Project	<b>IEEE 802.16 Broadband Wireless Access Working Group</b> < <a href="http://ieee802.org/16">http://ieee802.org/16</a> >	
Title	<b>Correction of inconsistencies in 802.16-2004 OFDMA mode repetitions and data mapping to burst</b>	
Date Submitted	<b>2004-07-06</b>	
Source(s)	Yigal Leiba Yossi Segal Zion Hadad Itzik Kitroser  Runcom Ltd. Hachoma 2 St. 75655 Rishon Lezion, Israel	Voice: +972-3-9528440 Fax: +972-3-9528805 <a href="mailto:yigall@runcom.co.il">yigall@runcom.co.il</a> <a href="mailto:yosis@runcom.co.il">yosis@runcom.co.il</a> <a href="mailto:zionh@runcom.co.il">zionh@runcom.co.il</a> <a href="mailto:Itzikk@runcom.co.il">Itzikk@runcom.co.il</a>
Re:	Handling corrections to P802.16-REVd/D5	
Abstract	Errata to 802.16-2004	
Purpose	Correction of inconsistencies in 802.16-2004	
Notice	This document has been prepared to assist IEEE 802.16. It is offered as a basis for discussion and is not binding on the contributing individual(s) or organization(s). The material in this document is subject to change in form and content after further study. The contributor(s) reserve(s) the right to add, amend or withdraw material contained herein.

## Correction of inconsistencies in 802

[Replace figure 216 with the figure shown below]

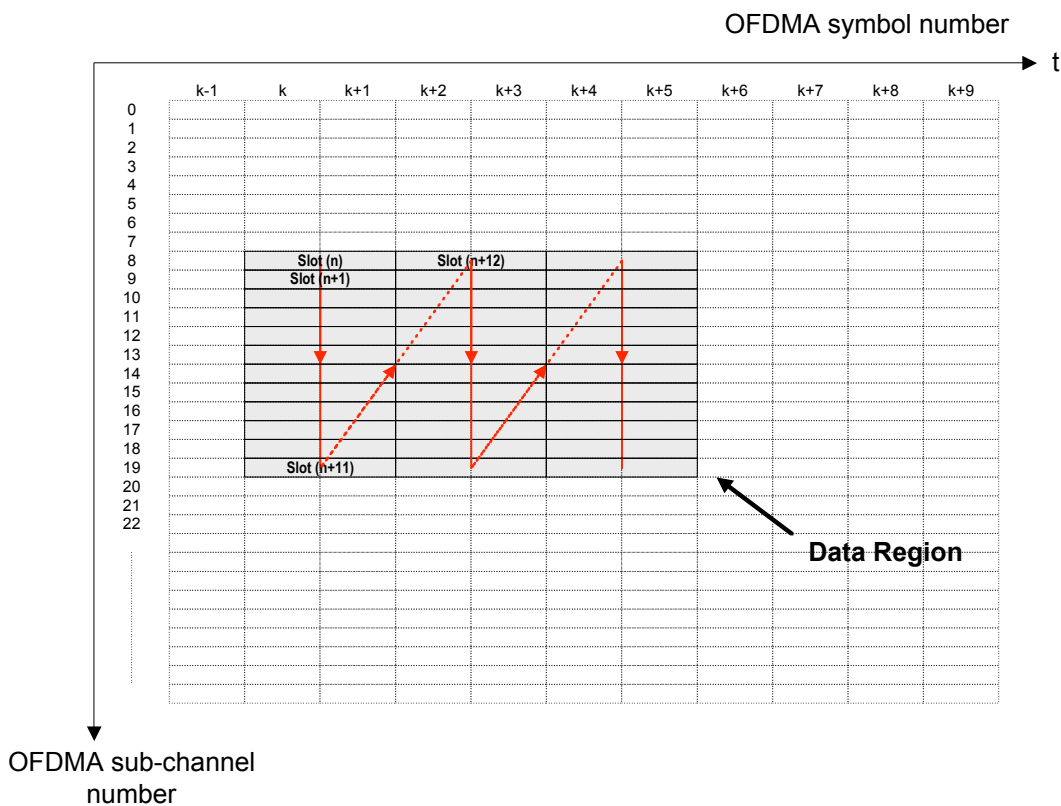
- 1) Segment the data into blocks sized to fit into one OFDMA slot.
- 2) Each slot shall span one or more subchannels in the subchannel axis and ~~two~~ **one or more** OFDMA symbols in the time axis (see Figure 216), as per the specific slot used. Map the slots such that the lowest numbered slot occupies the lowest numbered subchannel in the lowest numbered OFDMA symbol.

3) Continue the mapping such that the OFDMA ~~symbol~~ subchannel index is increased. When the edge of the Data Region is reached, continue the mapping from the lowest numbered OFDMA ~~symbol~~ subchannel in the next ~~subchannel~~ available symbol.
